HISTORIC PRESERVATION BOARD STAFF REPORT

108 N. Swinton Avenue

| Meeting | File No. | Application Type |
|--------------|----------|--------------------------------|
| June 5, 2024 | 2024-150 | Certificate of Appropriateness |

The item before the Board is consideration of a Certificate of Appropriateness (2024-150) for exterior modifications to gable ends and trellis feature to the contributing single-family residence located at **108 N. Swinton Avenue, Old School Square Historic District.**

EAST ELEVATION

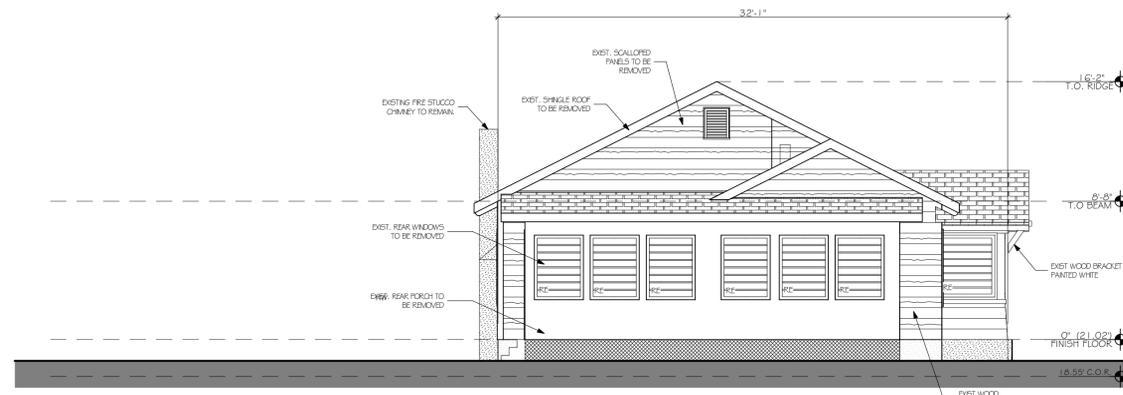
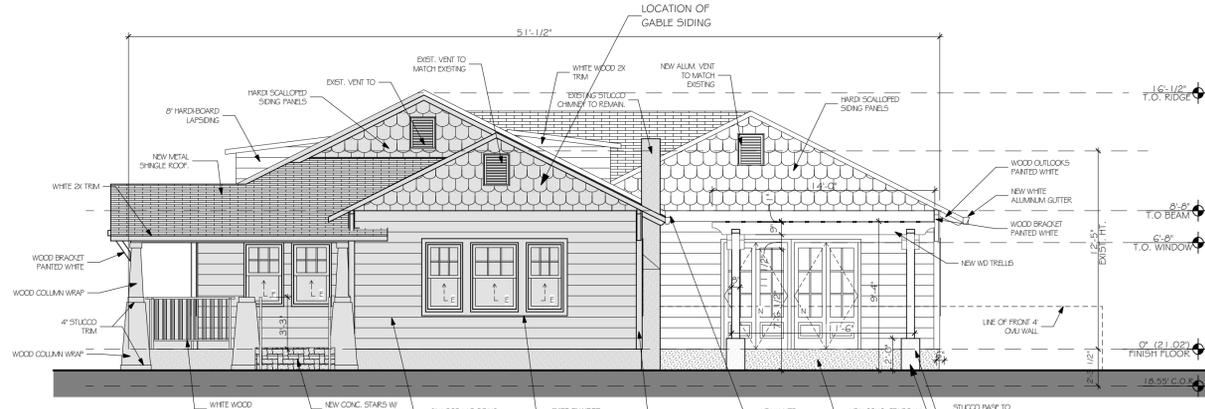
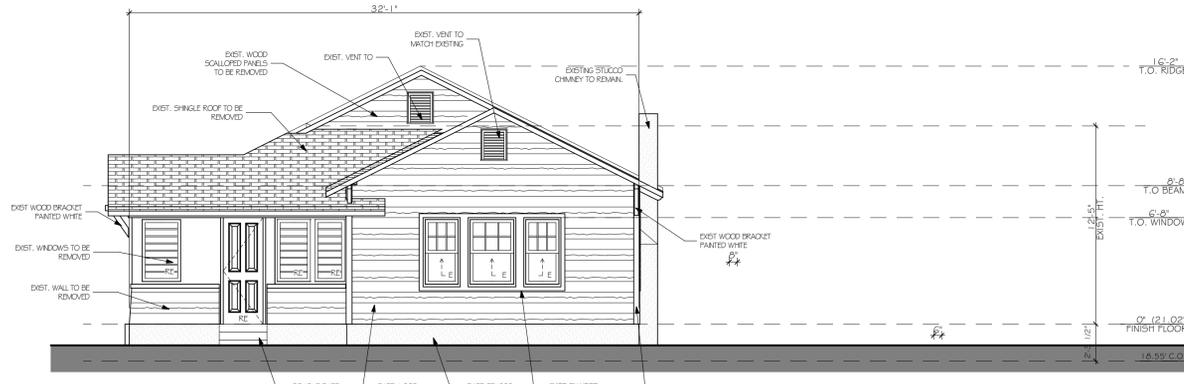
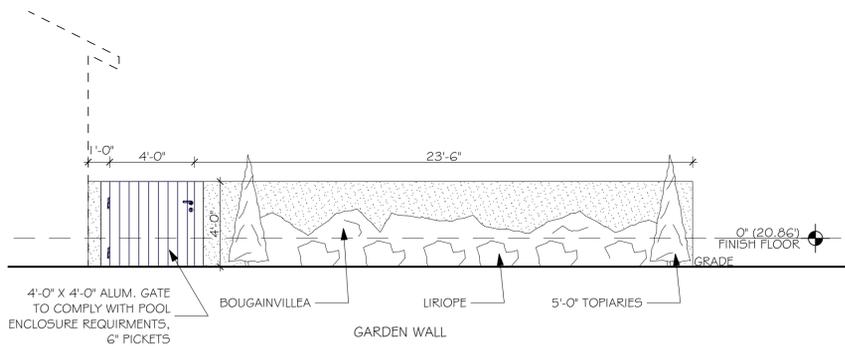
The subject request is for exterior modifications to the approved scalloped wood siding on the east (front) and south gable ends of the restored porch and addition of a stucco base to the trellis to a contributing one-story residence. The original design of the existing structure has been considered with respect to improvements.

front façade, and retains the appearance of an accessory structure. There is concern however, that the proposed footers may create a similar appearance to the columns on the adjacent porch, along with making the trellis appear larger potentially competing with the front of the existing structure. The board will have to make a determination that the size, material, and color of the stucco support bases are appropriate and compatible with the Bungalow style residence. With regard to **Standards 9 and 10**, the proposed trellis modification is a detached, accessory, structure and the proposed materials are anticipated to be compatible with the materials used on the existing historic structure.

Regarding the scalloped Hardie-board siding around the east and south facades of the home, there is concern with the use of composite materials on the historic structure. It is noted that the board approved the use of Hardi-board gable material in the rear of the property as such was associated with the new addition eliminating any negative effect upon the historic structure. The applicant has indicated there is difficulty meeting wind load calculations and insurance requirements with the custom wood siding. Consideration could be given to the amount of scalloped siding proposed and the particular elevations affected, such as the front versus the side interior.
